**Request for information from QT Lakeview Developments Limited in relation to the Lakeview Taumata resource consent application under the COVID-19 Recovery (Fast-track Consenting) Act 2020**

The Lakeview Taumata Expert Consenting Panel (the Panel) has directed the Environmental Protection Authority (EPA) to request further information from QT Lakeview Developments Limited under clause 25 of Schedule 6 of the COVID-19 Recovery Act 2020 (the Act), relating to the Lakeview Taumata resource consent application.

**Figure 3:** Viewpoint map

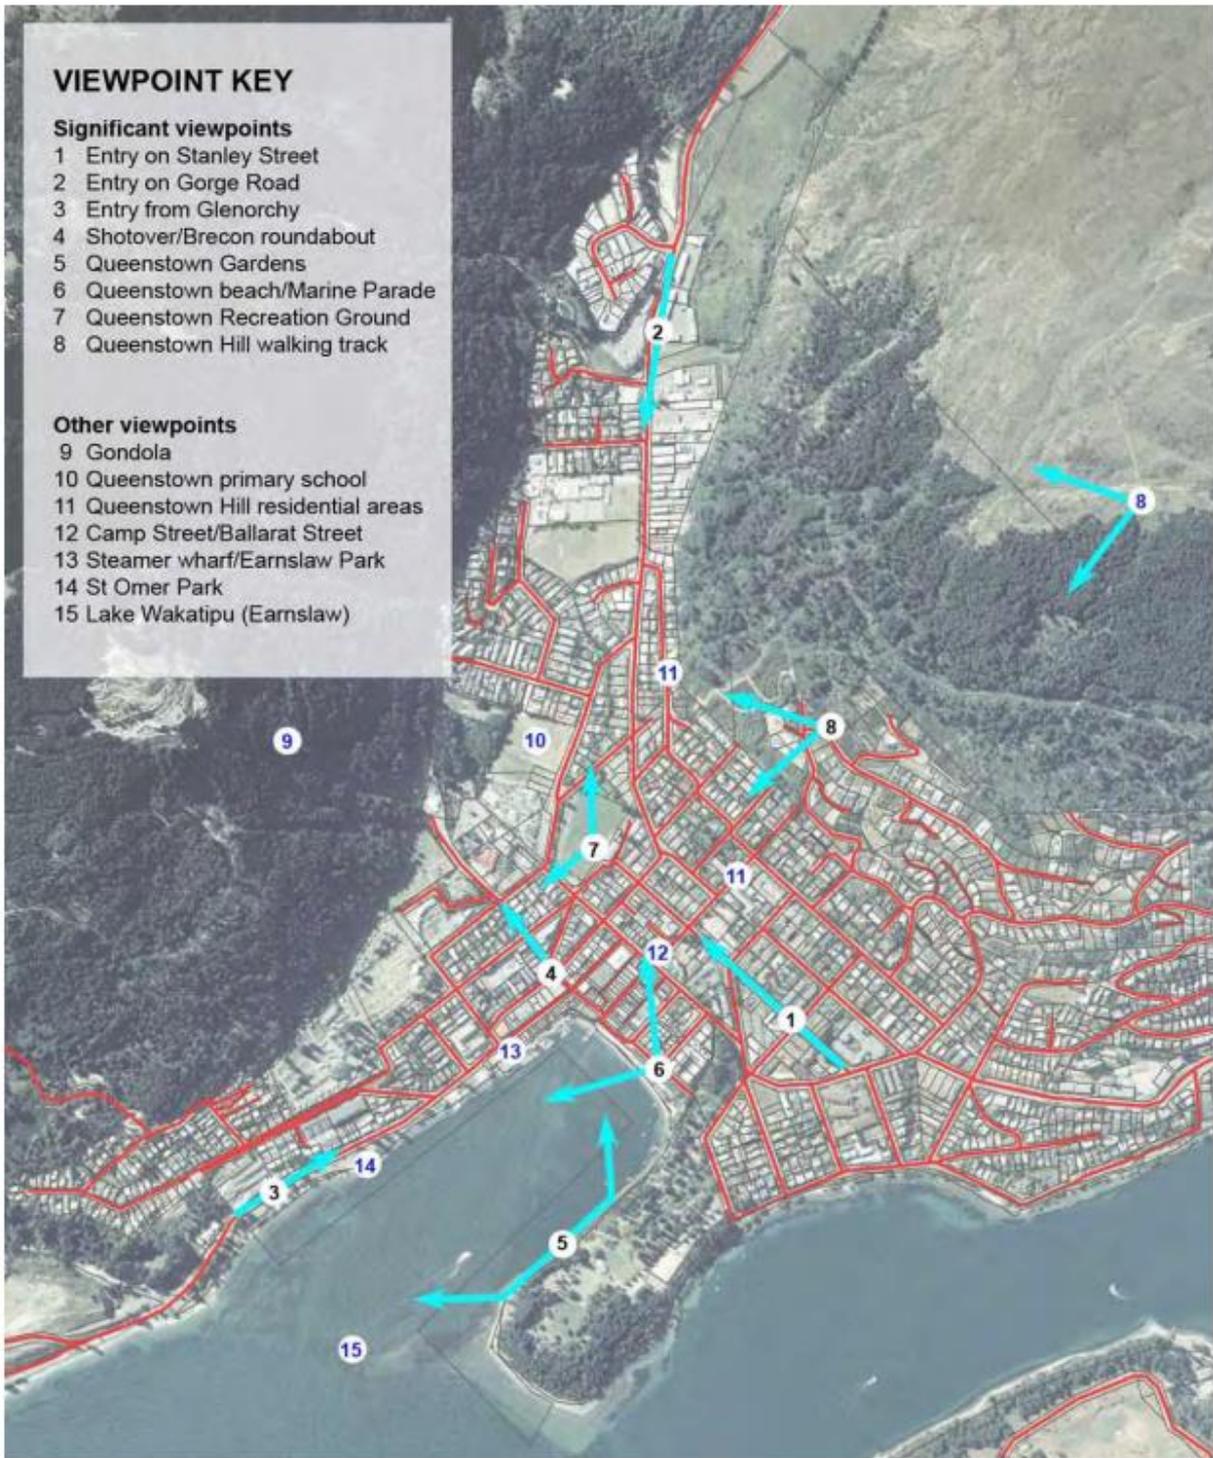
5. Please provide equivalent simulations of the proposed development from the viewpoints contained in the Landscape & Urban Design Assessment prepared by Helen Mellsop and Nick Karlovsky for Queenstown Lakes District Council, dated November 2009, which supported Plan Change 50 to the Queenstown lakes District Council Operative District Plan.

Please see the figure below for the location of each viewpoint. This figure can be found on page 21 of the Landscape and Urban Design Assessment.

We request the Applicant to assess the PC50 and proposal's comparative viewpoints and provide expert comment on the proposal's consistency with the outcomes visualised at the time of PC50, as part of its case that the proposal is in line with PC50's provisions.
